UNITED STATES PATENT AND TRADEMARK OFFICE

10/652,322

Office Action Summary

DETAILED ACTION

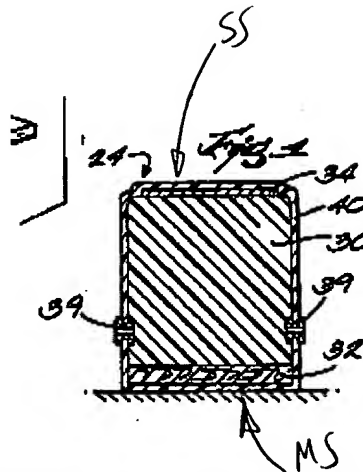
flexible, is obviously also "pliable". With regards to the heat shield and it being formed from either nylon or polyester, it is old and very well known in the art that both nylon and polyester materials are available in flexible or "plastic"/bendable forms, thereby also obviously being "pliable". Regarding claim 2, the heat shield (34) is interposed between the cover (40) and the core (30). In reference to claims 3-6, 17, 18 and 19, it would have been obvious to one having ordinary skill in the art at the time the invention was made to select a known material suitable for the use intended as an obvious matter of design choice. For instance, if the environment warrants exposure to extremely high temperatures, a material having a higher thermal conductivity would be required, and vice-versa. In further reference to claim 19, the same goes for the material's ability to compress and decompress. If the use thereof involves an extraneous need for being compressed, then a suitable material for that purpose would be warranted. Regarding claim 12 and further regarding claim 20, the dock pad further includes a backer (32) that is made from wood which obviously is more rigid than a foam core. In reference to claim 13, the dock pad also includes a sealing surface (SS) and a mounting surface (MS); wherein the heat shield (34) is closer to the sealing surface (SS), see below.

Regarding claims 14 and 15, the

dock pad has an elongate horizontal length (20) and two vertically oriented lengths (18,18') thereby forming an inverted U-shape. In reference to claim 16, STYBA does not disclose the use of an aluminum heat shield; however, it too would have been obvious to one having ordinary skill in the art at the time the invention was made to select a known material suitable for the use intended as an obvious matter of design choice.
